**SERVICE BULLETIN**

**DATE:** 17 January 2010

**REVISION:** A

**SUBJECT:** Service Bulletin for mandatory inspection and recommended replacement of Engine Intake Box and Control Cable.

**INSTALLATION OF THE ENGINE INTAKE BOX\*****NOTE:**

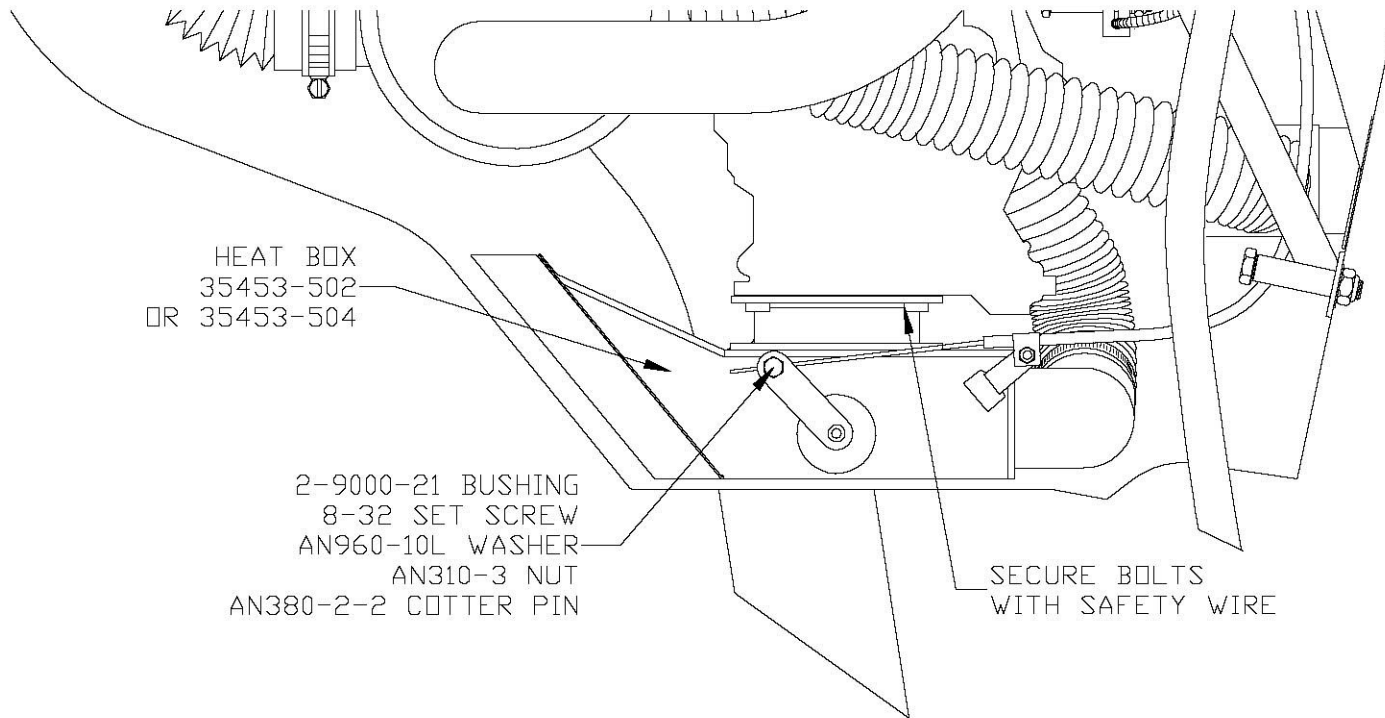
When installing new carburetor heat control mechanism verify positive travel stops when operating carburetor heat control.

1. Remove Screws from Lower Engine cowling at firewall and nose bowl to remove Lower Cowling. Care should be taken on removal to avoid any paint damage. Retain hardware (nylon washer and fillister screws), which may be re-used during installation.
2. Remove the air filter from engine intake box.
3. Remove the carburetor, hot air control cable attachment hardware.
4. Remove the scot hose from rear of intake box.
5. Remove the safety wire from the attachment bolts holding the intake box to the carburetor.
6. Remove the engine intake box and discard the old gasket.
7. Install the new engine intake box with provided gasket in reverse order as described above with the exception of the new carburetor heat control mechanism.
